St Marys Intermodal Modification 1

Rail refurbishment works package

State Significant Development Modification Assessment
(SSD 7308 MOD 1)

Published by the NSW Department of Planning, Industry and Environment

Figure 9 | Rail refurbishment works engineering drawings – Sheet 05 of 05 (Source: Applicant's Modification Report)

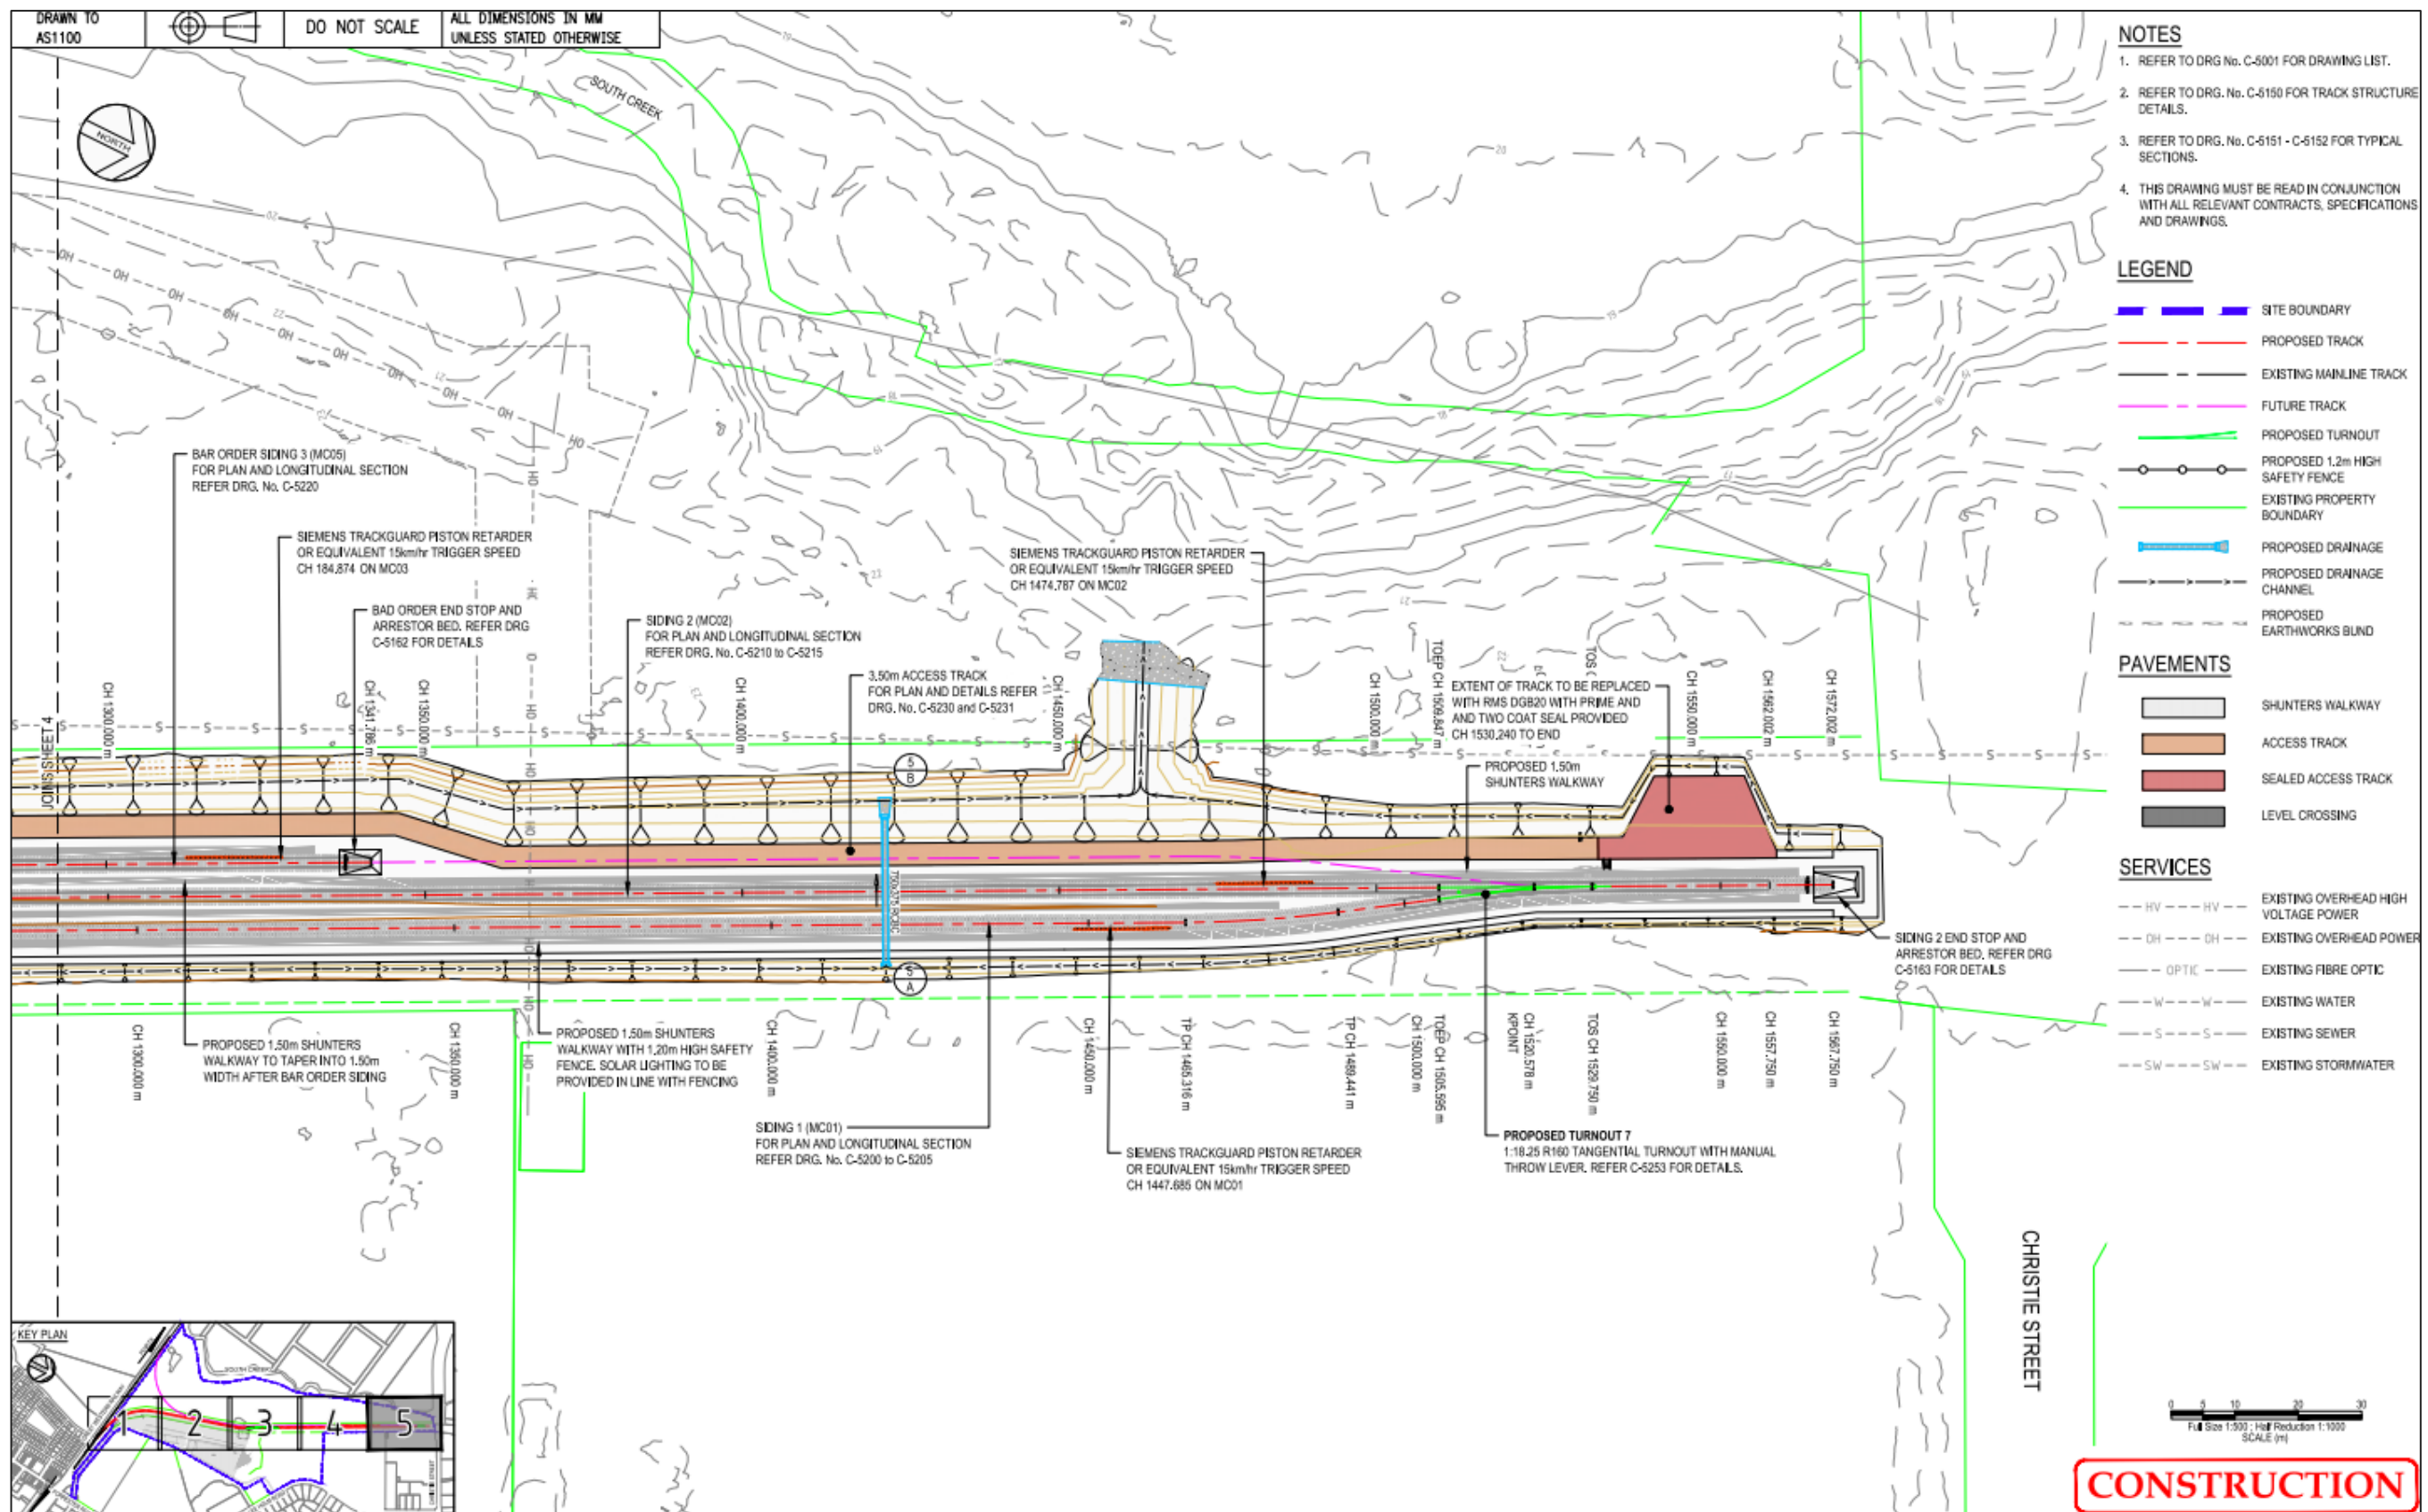
The proposal seeks to construct a 3.5 m wide one-way access track adjacent to the rail sidings and upgrade two existing level crossings (**Figure 5** to **Figure 9**). The access track would utilise an existing gravel access track that traverses Little Creek, to the immediate west of rail siding 2. The access track is proposed to run the full length of the rail sidings to allow light vehicles to transport locomotive drivers, enable access for maintenance works and allow track inspections during operation of the development.

As part of its submission on the modification application, Council requested a flood safety assessment be undertaken for the section of access track that traverses Little Creek, to assess flood velocity and depth for the safe access of vehicles, including possible warning signage, depth markers and potential upgrades to the pipe culvert to achieve flood safe access. As part of the RtS, the Applicant advised that the low point in the access track is subject to high hazard flood conditions during the 1% AEP event during both existing and post-developed peak-flow scenarios. To manage potential flooding impacts, the Applicant proposes to implement flood warning signage at the low point across Little Creek, enforce conditions for use of the access track in the Emergency Management Plan for the development, and restrict use of the track during flooding events. The Applicant also considered that upgrading the pipe culvert crossing Little Creek is not considered appropriate, as this would require raising the access track which has the potential to cause additional flooding impacts. The Department considers this approach to be acceptable.

Further, EESG recommended that an Emergency Management Plan be prepared for the development, to evacuate workers and users of the rail works area during a flood event. EESG also recommended the Applicant consult State Emergency Services during preparation of the plan, as the site is partially within the Hawkesbury-Nepean Regional flood extent. In response to advice provided by EESG, the Applicant advised that a site-specific Flood Management Plan would be implemented during operation of the development and would be maintained by the operator of the site.

Figure 10 | Proposed stormwater infrastructure for northern section of rail refurbishment works (Source: Applicant's Stormwater Management Design)

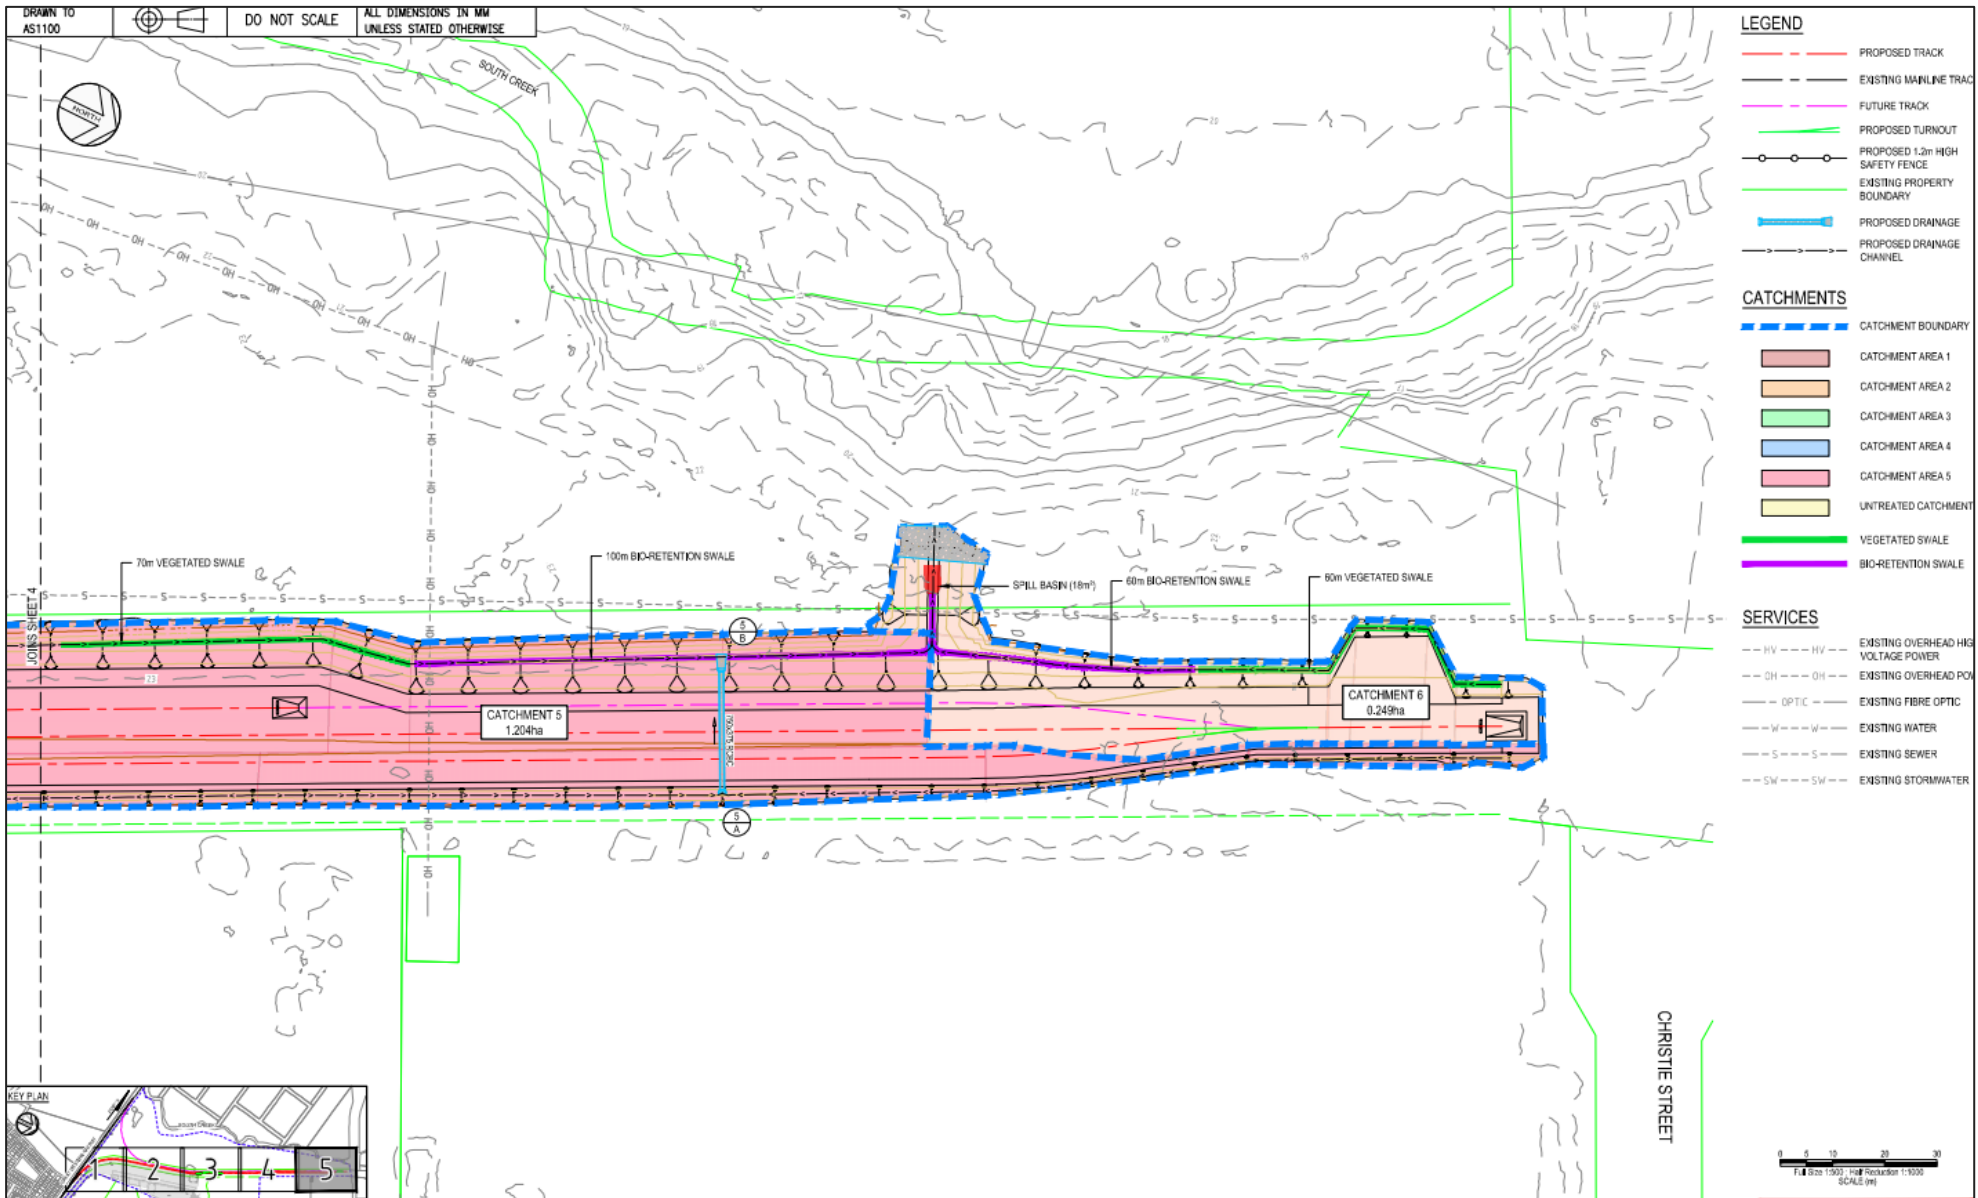
The Department has carefully considered concerns raised by Council regarding the appropriateness of the proposed permanent stormwater infrastructure located within RE1 Public Recreation land. Notwithstanding, the Department is satisfied that suitable provisions exist under State Environmental Planning Policy (SEPP) (Infrastructure) 2007, to allow development for the purpose of stormwater management systems to be carried out by any person with consent on any land. The Department also acknowledges that the proposed stormwater and drainage works would improve existing stormwater management and water quality standards for discharge into Little Creek and South Creek. Consequently, the Department considers that the proposed stormwater management facilities and discharge outlet within the rail works area are acceptable.

Figure 12 | Construction compound area at northern portion of the site (source: Applicant's Modification Report)

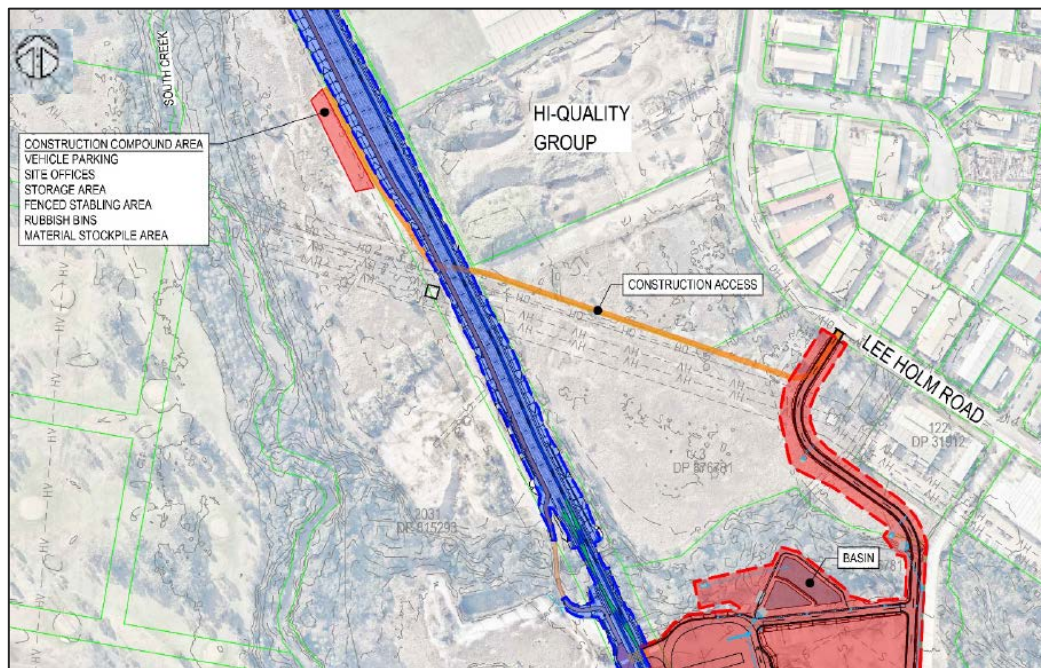
Further, as part of its submission on the modification application, and consistent with advice provided as part of SSD 7308 MOD 3, Council recommended that the Vegetation Management Plan (VMP) required under condition B33(g) be expanded to include the scope of works proposed on Lot 2031 DP 815293. In particular, Council recommended that the temporary construction compound area be rehabilitated to 'natural vegetation conditions', rather than 'pre-existing conditions' that are currently present on the exotic/cleared compound area.

In response to Council's concerns, the Applicant considered that rehabilitation of the construction compound area and revision of the VMP is not feasible for the following reasons:

- site surveys of the construction compound area found that no biodiversity values exist on the compound site. The area is cleared and has no vegetation (**Figure 13**)
- the construction compound area is used for access and storage, and will continue to be used as such until the rail refurbishment works are complete
- Lot 2031 DP 815293 may continue to be used for industrial activities in the future.
